DEVELOPMENT REVIEW BOARD REPORT

CASE NUMBER/
PROJECT NAME **77-DR-2005**
 6th Street Lofts

REQUEST Request approval of a site plan and elevations for five (5) attached townhomes on a 0.31 acre parcel.

BUILDING
ELEVATIONS

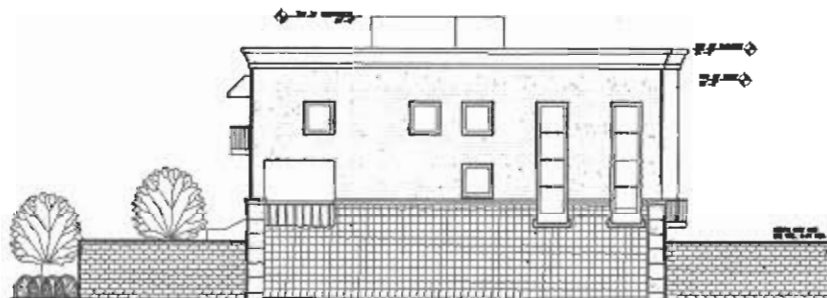
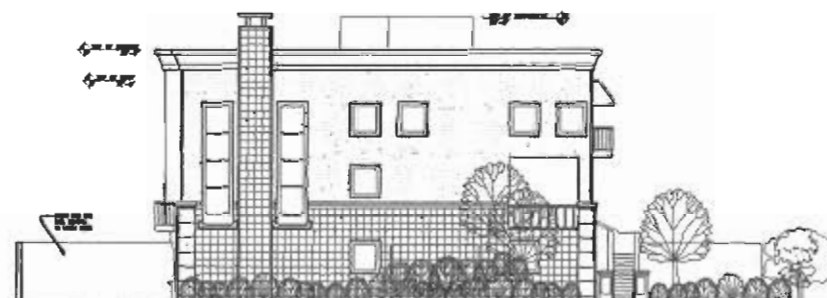
In general, the CMU block will be located along the western (front) elevation on the first floor façade, where the stairwell rises from the ground level to the front doors of the units (located on the 2nd floor). There will be painted trim wood railings on the front of the porch, with smooth stucco on the majority of the face of the building at the 2nd and 3rd levels, along with a smooth stucco capstone at each of the columns that terminate at the raised front porch. The applicant is proposing canvas awnings. These types of awnings, unless maintained and replaced, will fade or decompose due to the extreme heat. Staff has added a stipulation requiring the awnings to be made of metal.

7. Dooley wall fencing shall not be allowed.
8. All walls shall match the architectural color, materials and finish of the building(s).
9. *Awnings shall be metal.*
